Appendix A – Supporting Technical Reports

From: Colin Hattingh
Sent: Friday, 17 February 2023 2:42 pm
To: Laura Galt
Subject: UD Comment: Plan Change 13 Te Rapa Racecourse

PLAN CHANGE 13 - TE RAPA RACECOURSE: TRANSPORTATION REVIEW – ISSUE 5

Te Rapa Racecourse Private Plan Change - Review of Stormwater and Wastewater

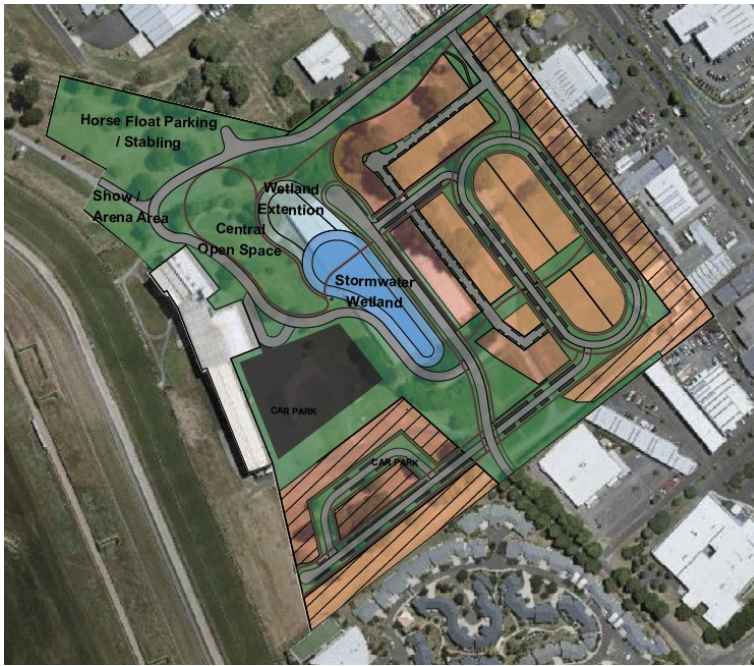
- In relation to the concept masterplan, the following comments are relevant:
 - *“there is a disconnect between the two designated development areas”* and that the housing should respond to and integrate with the open spaces.

- The panel raised concerns regarding the proposed racetrack shape particularly in respect to visibility (safety)
- As illustrated below, in response to the Panel’s recommendations, the concept plan was completely revised noting changes that will help future flexibility, a range of dwelling typologies, improved integration of the open space elements and the improved / safer roading layout.

Figure 4 Proposed changes to Te Rapa Road / Sir Tristram Ave intersection

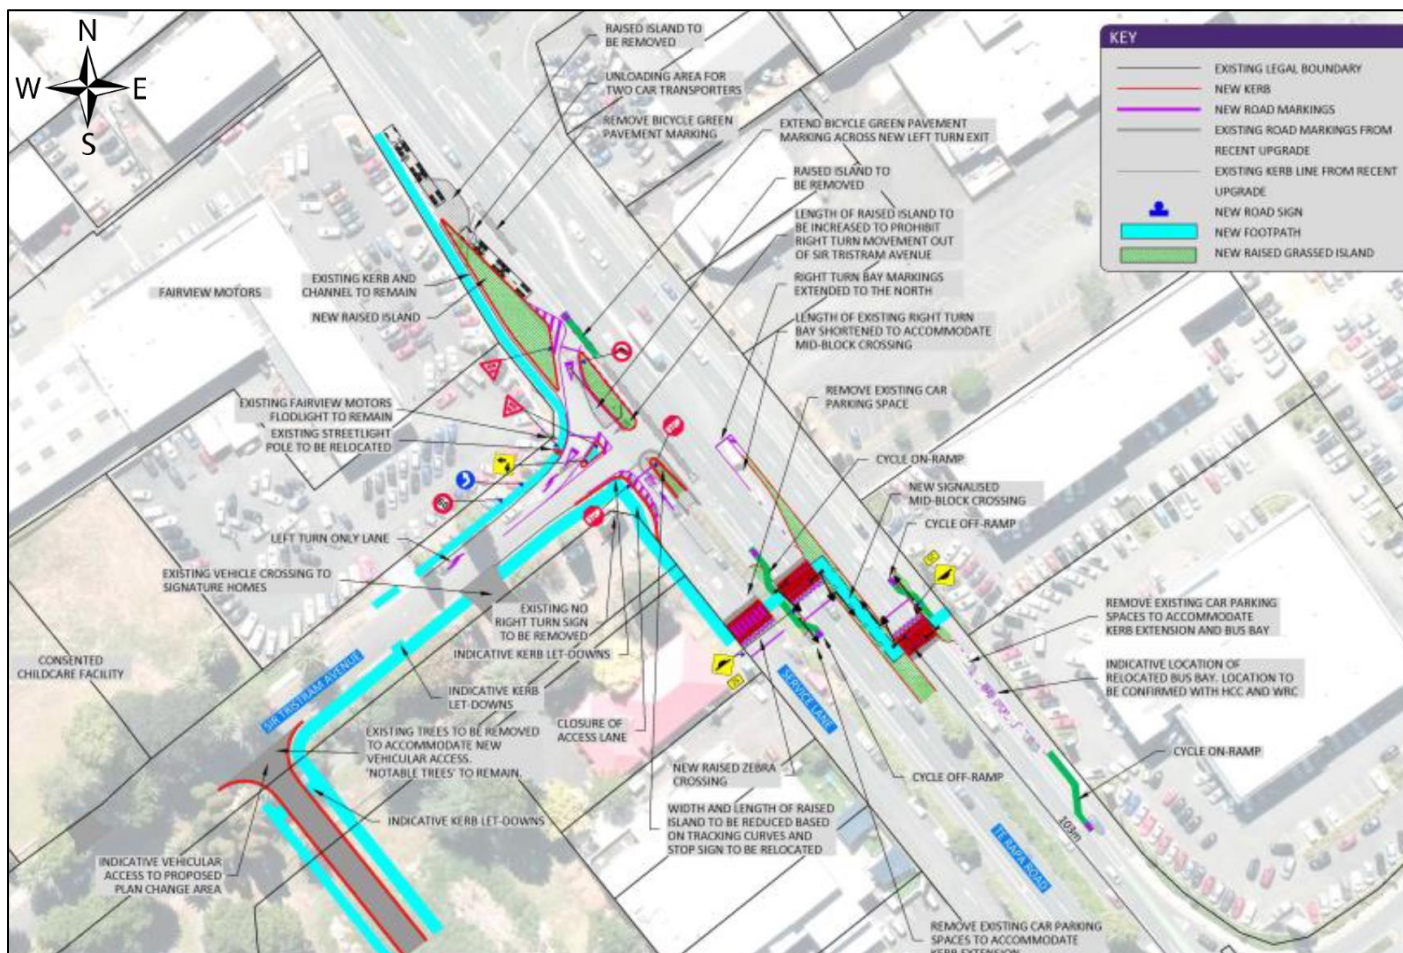
The ITA includes proposed changes to the recently modified Sir Tristram Ave/ Te Rapa Road intersection, illustrated in the extract below. To summarise, the changes ban right turns out of Sir Tristram Ave, reducing the skew where the service lane intersects Te Rapa Road, and add an on-street loading area for Fairview Motors to unload and load vehicles using car transporters.

The sealed width of Sir Tristram Ave is 7.6m. The District Plan requires recessed parking and footpaths on both sides of local roads. This is currently not provided. Depending on the level of parking provided on the individual lots, there is a risk of parking overspill from the residential development competing with parking demand from the surrounding industrial and commercial activities, as well as race day activities.

We consider the ITA proposal to add a footpath on the southern side of the road to be sufficient, provided that a safe crossing point of Sir Tristram Ave is provided.

Figure 5 Semi-trailer tracking

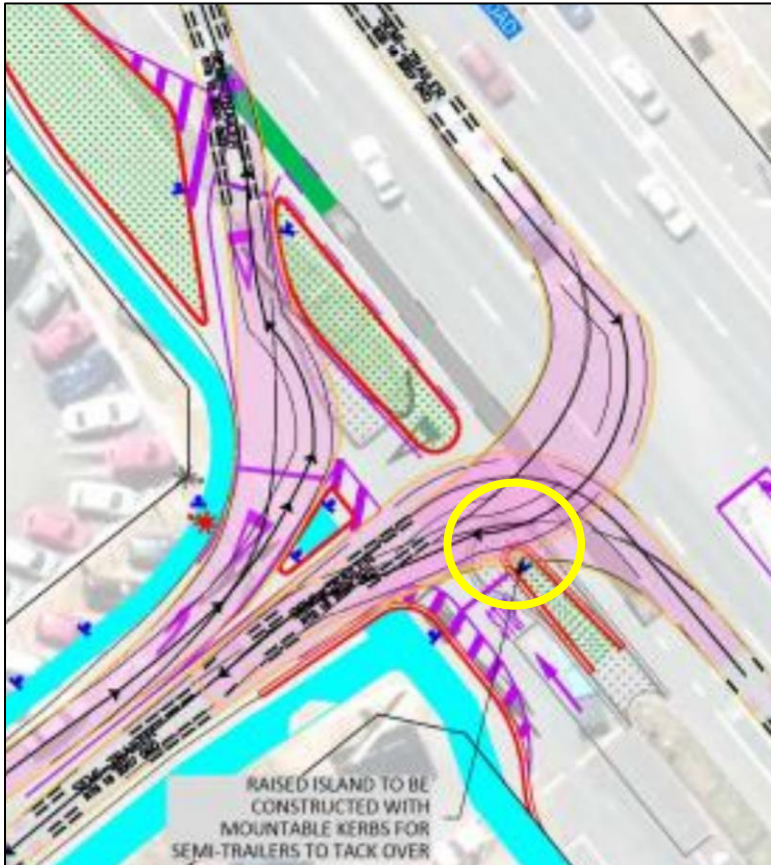
The ITA includes tracking drawings. Tracking is acceptable for both cars and trucks with the exception of the movement that requires a semi-trailer to turn left from Te Rapa Road into Sir Tristram Avenue. In this case the vehicle will track over the island kerb (indicated by the yellow circle below). Although this intentional, there is a risk of damage to any signage placed on this island (e.g. no entry signage, stop signage). The frequency of semi-trailers turning left into the intersection, and therefore the associated risk, is likely to be low. The exact location of any signage can be determined during the design stage.

Figure 7 Proposed pedestrian crossing facility

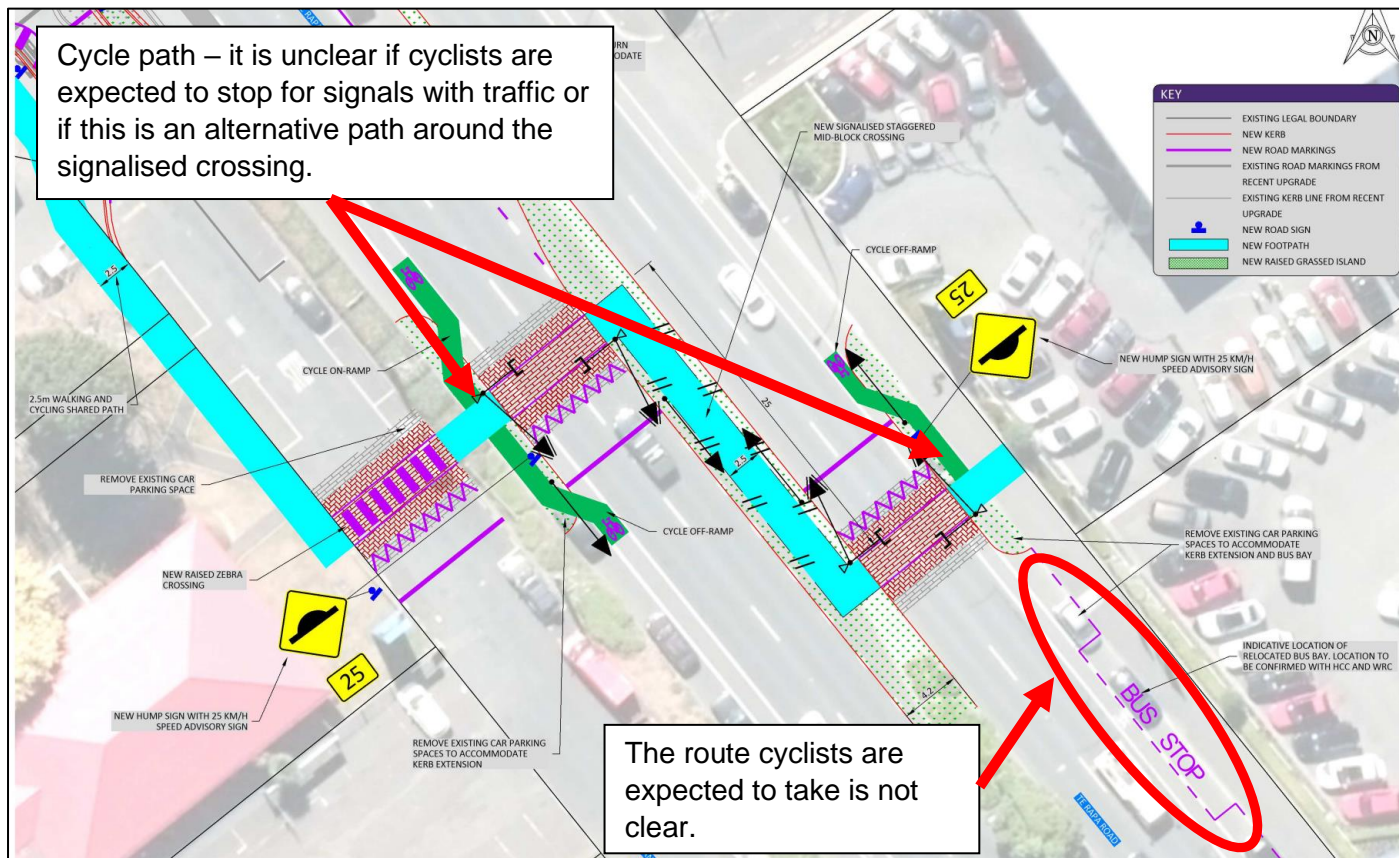
- = The concept plan shows on-ramps and off-ramps for cyclists at the pedestrian signals. This is confusing and may lead to conflict between pedestrians and cyclists. It would be preferable for cyclists to have a designated green stopping area at the signals and to remain on the same path.
- = Southbound cyclists have no clear route past the relocated bus stop. The on- and off-ramps indicate that they should use the footpath, however this is undesirable and presents a safety risk.

In addition, we note that kerb extensions may be need to both sides of the service lane to enable pedestrians to see past parked cars and past the loading bay. Currently shown on one side only.

The above issues can be addressed during detailed design, which should undergo safety audits.

Figure 8 Concept Plan (ITA, Figure 19)

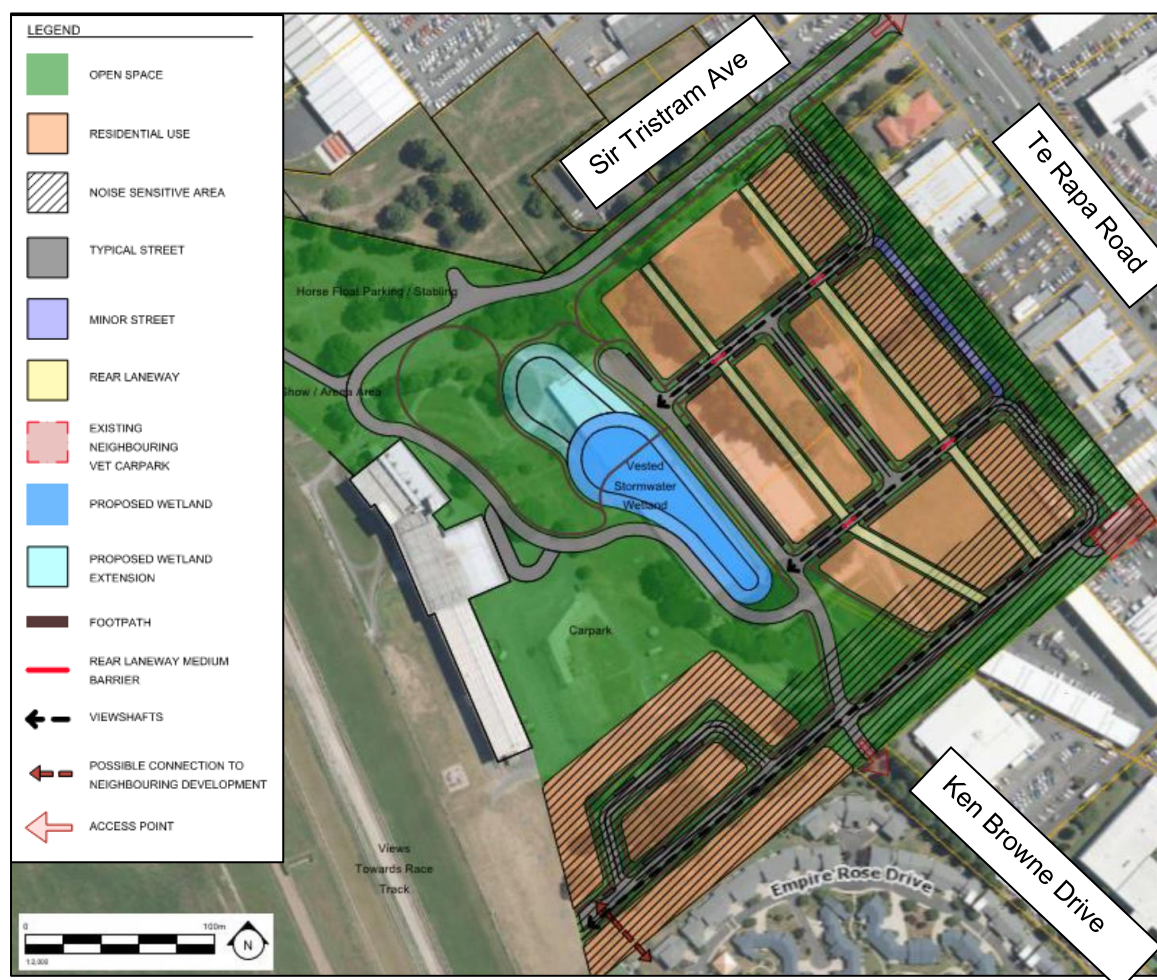
Section 4.3 of the ITA provides some guidance on road design, including a road reserve width of 16m instead of the 20m required for local roads in the Operative District Plan. The ITA and cross-sections provided indicate that footpaths will be provided on both sides of the roads. We recommend that the minimum width be increased to 16.8m to align with the decisions version of PC5 (Peacocke) and notified version of PC12. The additional width provides 2.1m for parking and 1.5m for service corridors.

There is support for the access lanes to be connected to the road network at both ends. We agree that to enable walking and cycling and provide a permeable development the use of cul-de-sacs and right-of-ways should be minimised. Most of the proposed roads are connected at both ends. The precinct plan in the ITA indicates there is one cul-de-sac⁸ affecting less than 50m of road.

The proposed layout is acceptable and will be reviewed at the time of subdivision for compliance with the District Plan rules relating to length, width and number of dwellings accessed from a lane.
